NOTE FOR VERSION CHANGE:

00 -> 01

CABLE P/N: 4260518-01

INVERTER CABLE PHR5/XHP-4,5, 300mm

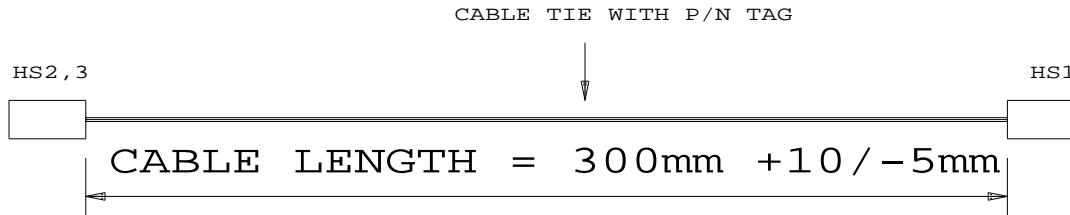
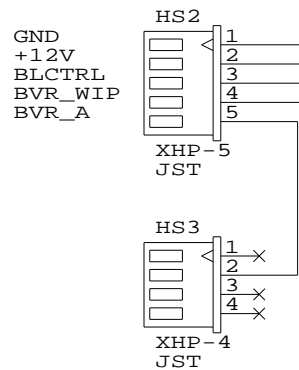
- CORRECTED CONNECTORS REFERENCE NAME
- CHANGED HS2.5 TO HS3.2 WIRE LENGTH TO 60mm
- STATED HS1 MUST USE JST
